Harnett County Department of Public Health Improvement Permit

PROPERTY LOCATION: 4195 McNeill Rd.

ISSUED TO: Cynthia McKoy SUBDIVISION Hunters Pointe LOT # 5

Harnett County Department of Public Health Site Sketch

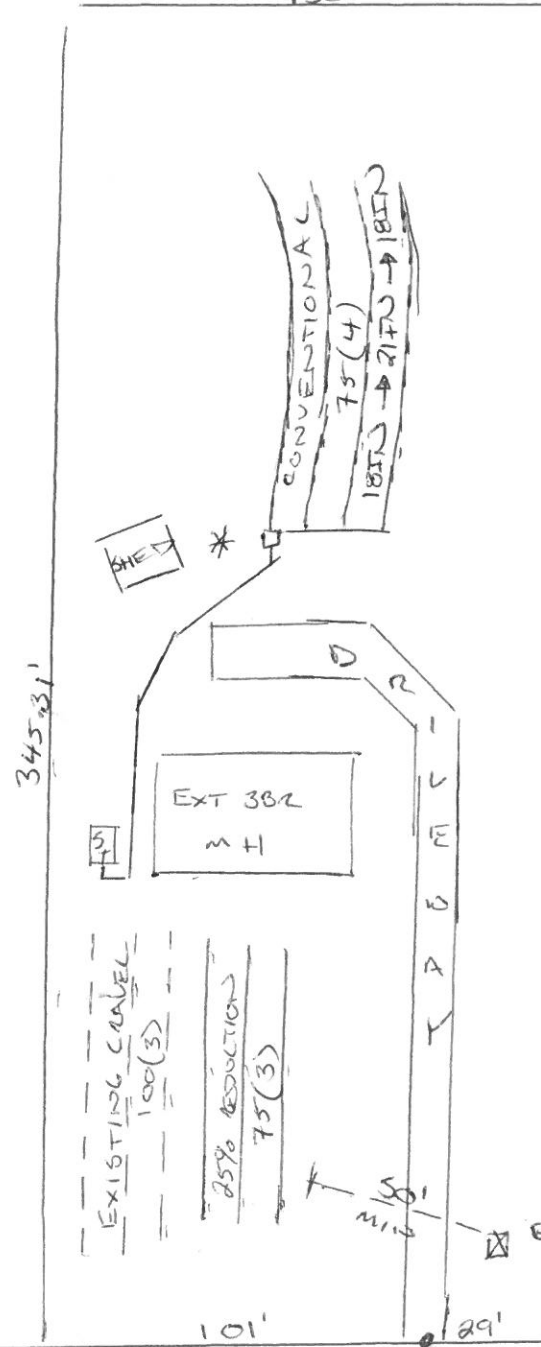
Authorized State Agent: Andrew Curran Date: 04/10/2019 (AIL)
130' 04/30/2019.

- * 50FT EXT well setback
- * EXT WATER AND POWER SHALL BE LOCATED PRIOR TO INSTALL
- * 10FT WATER LINE SETBACK [MAY REQUIRE RELOCATION]
- * D-BOX MAY REQ. REPLACEMENT
- * 300FT CONVENTIONAL IF AVAILABLE SPACE
- * TANK SHALL BE UNCOVERED, PUMPED AND INSPECTED W/ AFFLUENT FILTER AND
- EXISTING WELL PUC TEE ADDED
